Permit No: 0315828

Site Address: 5534 DUNLAY DR SAC

Re: Front Entry Holdowns: Plan 2389 Northborough Village 8-4
O'Connor Freeman Job Number: E020611

PROBLEMS WITH PLAN 2389

#1 **F** SHEAR WALL AT ENTRY

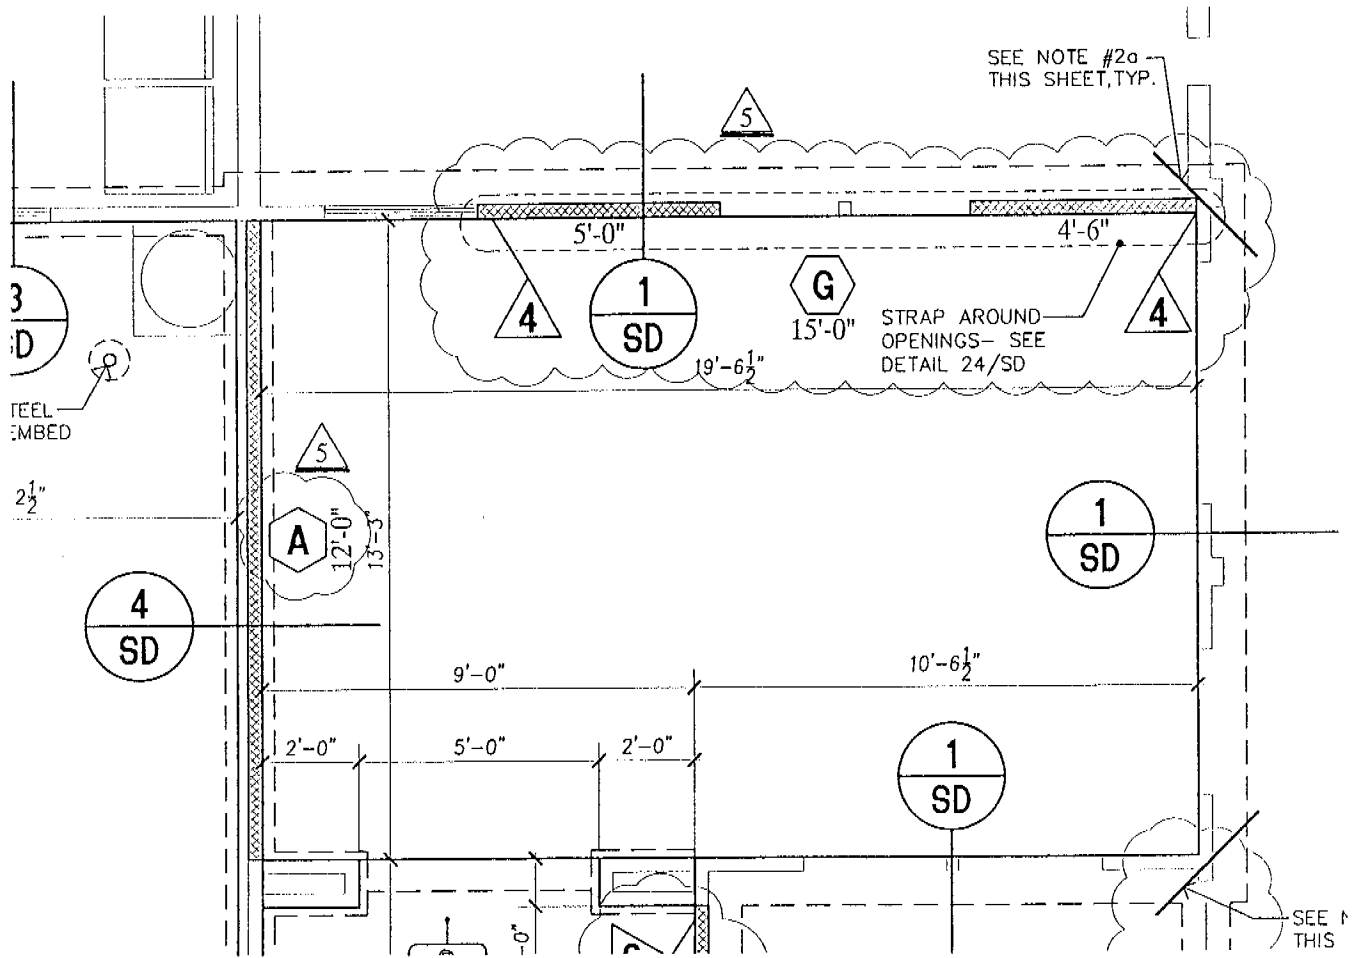
5/8 FOR DOOR JAM'S OK FOR STA ENTRY

IF OPTIONAL ANDERSON FRENCH DOORS ARE USED IN DIVISION

WE HAVE A PROBLEM. ALSO THE USE OF

THE HD 10A HOLD DOWN DO WE HAVE ANY

OTHER OPTIONS? THE TRIM BULGING IS GOING TO

CAUSE PROBLEMS.

IF WE CAN WE NEED TO DELETE THE

5/8 SHEAR AND CHANGE THE HOLD DOWNS TO

SOMETHING MORE USER FRIENDLY

In response to your request, we have reevaluated the lateral loads to the front entry shear wall in order to determine if the holdown could be changed. As a result of our analysis, we found the shear wall sheathing would remain the same. However, by strapping around the window opening, we can reduce the holdown size. We have adjusted the plans to reflect this information. See the attached partial plan exhibits and structural calculations for reference and review.
